Sapgaon Rural Water Supply Scheme
Village: Sapgaon, Taluka: Shahapur, District: Thane
Assessment Report

April 2017

Technology and Development Solutions Cell (TDSC)
Centre for Technology Alternatives for Rural Areas (CTARA)
Indian Institute of Technology Bombay
Powai, Mumbai

Figure 6: Existing scheme diagram

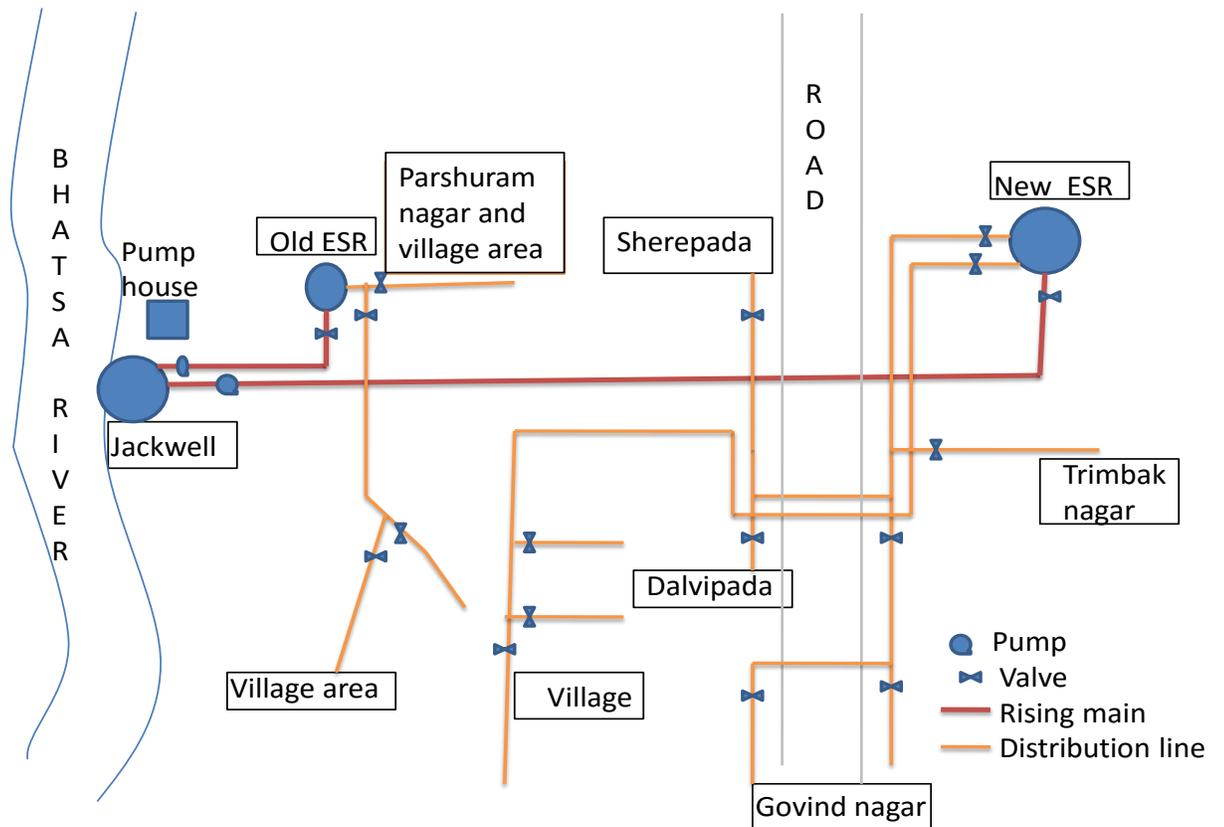
- **Rising main** – Separate rising main for old ESR and New ESR. For old ESR PVC pipe used for rising main from the old Scheme. HDPE pipe having 110 mm diameter of 1550 meter length of PE-100class rising main runs from jackwell to new ESR. Both rising mains are of G.I material upto pump house. Rising mains are resting on temporary support as seen in Figure 3
- **ESRs**–Old ESR is near to the Jack well, this was repaired. The stair for old ESR is in deteriorated condition, not safe for use. The New ESR is 1.5 Km far from the Jackwell and has a capacity of 105000 liters. There is no overflow pipe & wash out valve in both ESRs. Staging height of new ESR is changed from 12 m to 9 m.

- Jack well is deteriorated; cracks are seen on the wall of Jack well.
- Wash out valve & over Flow valve not present in the both the ESR.
- Rising main is resting on temporary supports.

- New jackwell is required.
- Proper concrete block construction is required to support rising main near jackwell.
- Air valve should be provided on rising main and distribution main.
- Construct chamber around operation valves to avoid damage.
- Wash out valves and overflow pipe which is connected to outflow pipe should be provided at both ESRs.

Figure 7: Distribution system diagram

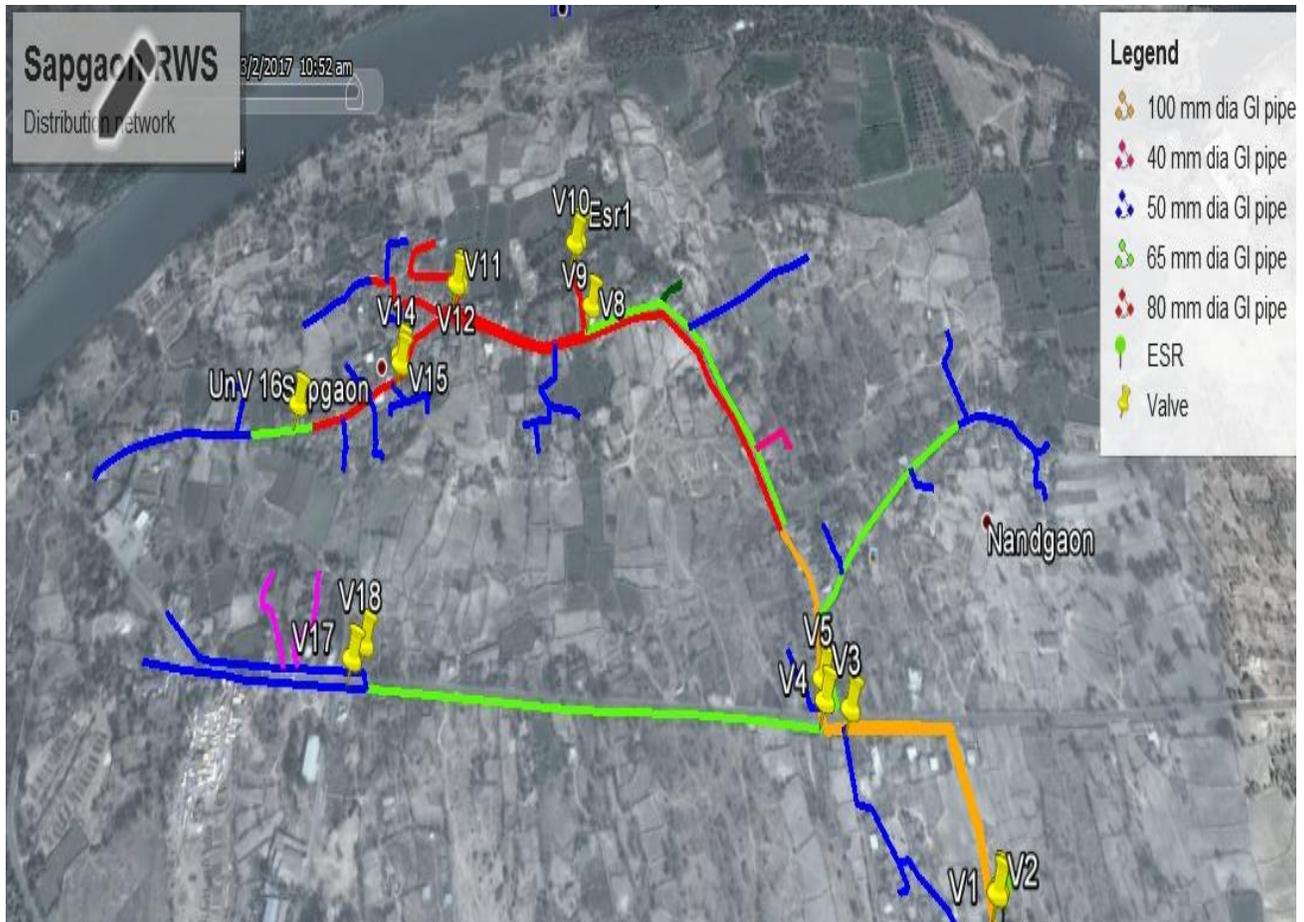
Two distribution main lines emerge from new ESR; one directly goes to main village area and then it is divided in three sub lines. Each sub line has valve, water is supplied to this zone from 7 am to 10.30 pm. Second distribution line is divided into four branches, one goes toward sherepada other to dalvipada third to Trimbaknagar and last one to Govindnagar.

- Chamber is not provided anywhere for valves, if chamber is present, they are in broken condition.
- We could not verify distribution network as survey map is not available. Design document and drawing in villages show different picture than actual network on field.

- All the habitations are covered in the scheme; 86%houses have household connections.
- Parshuram Nagar which is located on high elevation has problem of low pressure, water hardly reached to that area.
- 2-3 sub distribution line running from Govind nagar main distribution lines are laid by Gram Panchyat.
- Area along main Kinhavali main road is considered in designed but pipes are not laid in this area.

- Every household connection should have tap and a fine for noncompliance.
- New design and diagram according to which distribution network laid should make available so we can verify network.
- Sub line of distribution network which runs toward Parshuram nagar should have separate valve on Parshuram nagar subline to control pressure for distribution to Parshuram nagar.
- Pressure gauge and air valves should be installed on rising main.
- To reduce pumping hours, proper zoning of village is needed to be done.
